Fulmer St CDR Presentation

STONEMONT FINANCIAL INDUSTRIAL
1685 & 1719 FULMER STREET
OPA# 885000380 & 885000013
CITY OF PHILADELPHIA, PENNSYLVANIA

Drawing No.
C1.1

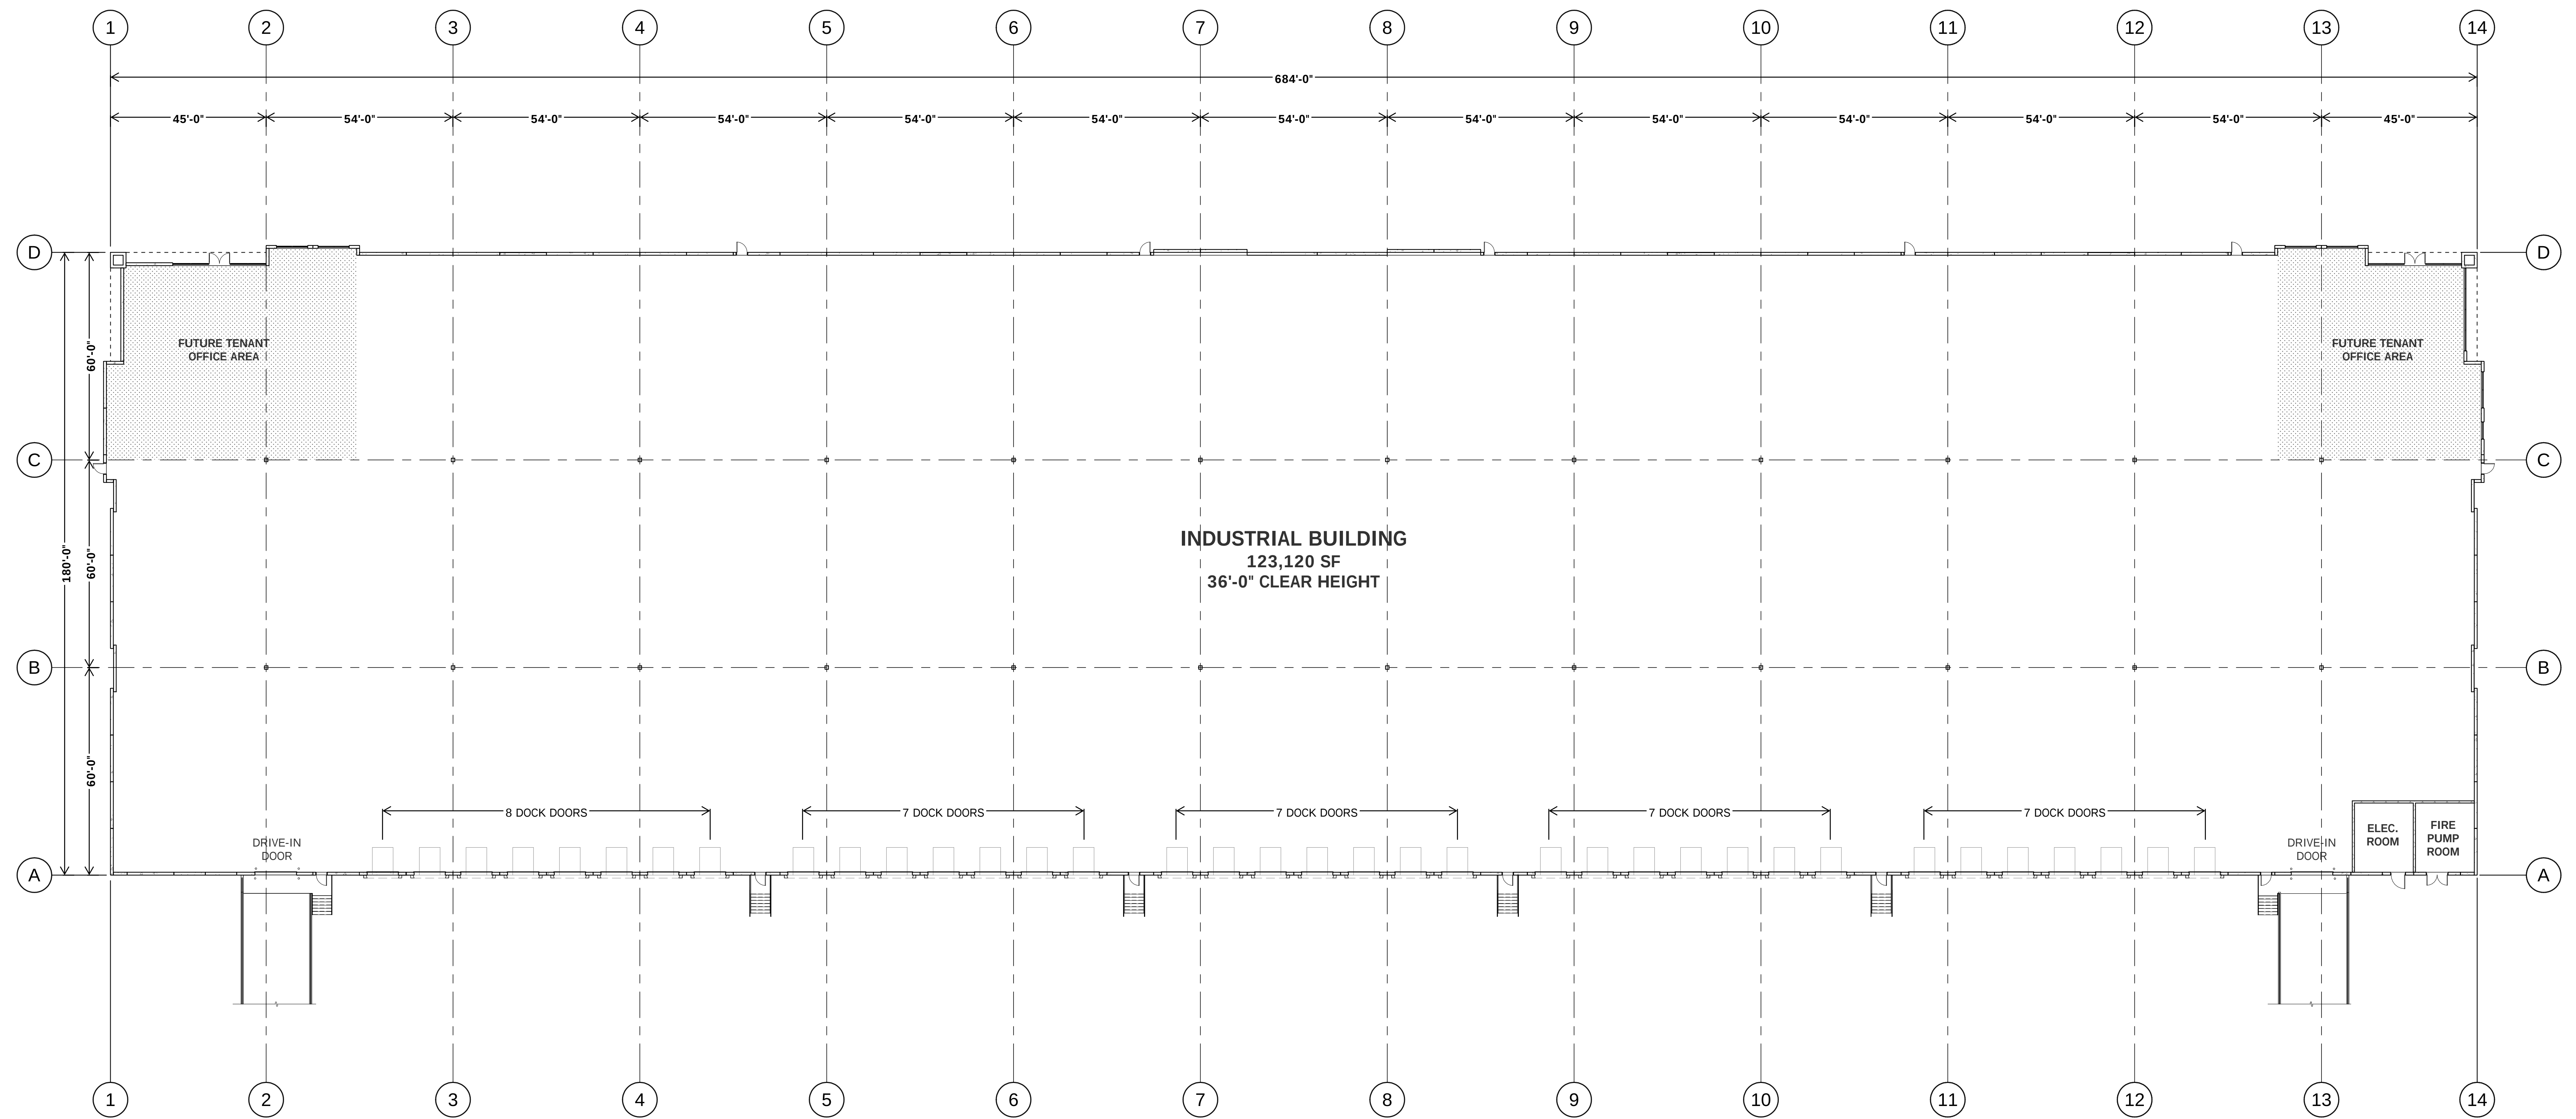
6	Add more site context to the plans and renderings. Acknowledged, please see revised submission materials.
7	Considers adding amenities for affected neighbors like pathways and sidewalks. Per the plans, a pedestrian sidewalk on the northern side of Fulmer Street has been proposed. In addition, ownership has added bicycle racks for the use of the neighborhood to the area immediately adjacent to the new Fulmer Street sidewalk. No on-site pathways or sidewalks can be accommodated due to safety concerns of interaction between pedestrian and truck traffic.
8	Develop a plan that will minimize idling trucks. Trucks will abide by all local and state codes regarding idling.
9	Increase the buffer between site and neighbors - maybe create a hill or a wall which will mitigate light and sound. A hill or berm is not an option due to the width of the required setbacks but per the above, we are updating our plans to include a wooden fence along Fulmer Street and we will be planting larger caliper trees to help minimize visual impacts.

10	Use larger trees in plantings. As noted on the plans, the existing heritage trees will be maintained on the property. We will also increase the previously proposed caliper of trees to be planted in the buffer areas. Additionally, we have provided buffering landscaping above the Code requirements.
11	Consider alternative building placement on the site for better circulation, keeping trucks far from the neighborhood, and to have different egress and ingress. We have evaluated all options before submitting the proposed project. We cannot change the orientation of the building due to site logistic issues, significant grade change, conflicts between crossing car and truck traffic, significantly taller building, required retaining walls. We have proposed the project with the same orientation as the previously approved industrial project and utilizing the approved Fulmer Street access points in alignment with the previous Streets approvals. We have further coordinated with the Streets Department through their technical review process.
